DART AEROSPACE LTD	Work Order:	97414
Description: Crosstube Assembly, Mid Fwd	Part Number:	D206-667-147TRN
Inspection Dwg: D206-667-147 Rev: A		Page 1 of 2

DART AEROSPACE LTD HAWKESBURY, ONTARIO, CANADA	
DRAWING NO. D206-667-147	REV. A SHEET 1 OF 4
TITLE CROSSTUBE ASSY (206L MID FWD)	SCALE NTS

DRAWING NO. D206-667-147	TITLE CROSSTUBE ASS'Y (206L MID FWD)	REV. A	DART AEROSPACE LTD ENGINEERING ORDER		D.E.O. NO. D206-667-147-A-1	SHEET NO. SHEET 1 OF 1	SCALE NTS
DRAWN <i>q</i>	CHECKED <i>ASS</i>	MFG. APPR. <i>JB</i>	APPROVED <i>MD</i>		DE APPR. <i>MD</i>		
DATE 11.07.15	DATE 11.07.20	DATE 11.07.21	DATE 11/07/21		DATE 11.07.21

DRAWING NO. D206-667-147		TITLE CROSSTUBE ASS'Y (206L MID FWD)		REV. A		DART AEROSPACE LTD ENGINEERING ORDER		D.E.O. NO. D206-667-147-A-2		SHEET NO. SHEET 1 OF 1		SCALE NTS	
DRAWN AJS		CHECKED		MFG. APPR.		APPROVED		DE APPR.		DATE		DATE	
DATE 12.08.02		DATE 12.08.02		DATE 12.08.02		DATE 12.08.02		DATE 12.08.02		DATE 12.08.02		DATE 12.08.02

DETAIL P
BONDING STRAP INSTALLATION 2 PL

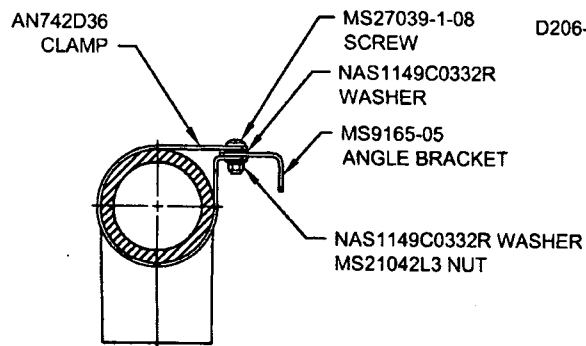
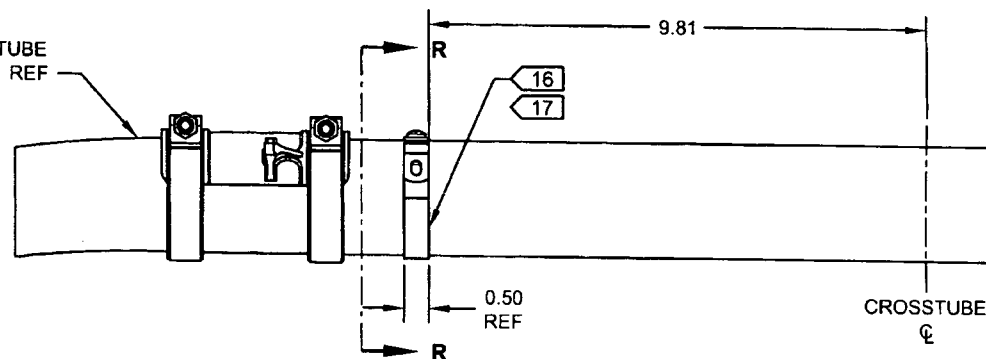
ADD ELECTRICAL GROUNDING STRAP

- 16) MASK AREA UNDER CLAMP PRIOR TO PAINTING
 17) SEAL EDGES WHERE AN742D36 CLAMP MEETS WITH THE CROSSTUBE USING SIKAFLEX-241/-291 OR MIL-S-8802 CLASS B2 OR PROSEAL 890 SEALANT
 18) PERFORM RESISTANCE CHECK TO ENSURE MAX RESISTANCE IS 10 MILLIOHMS
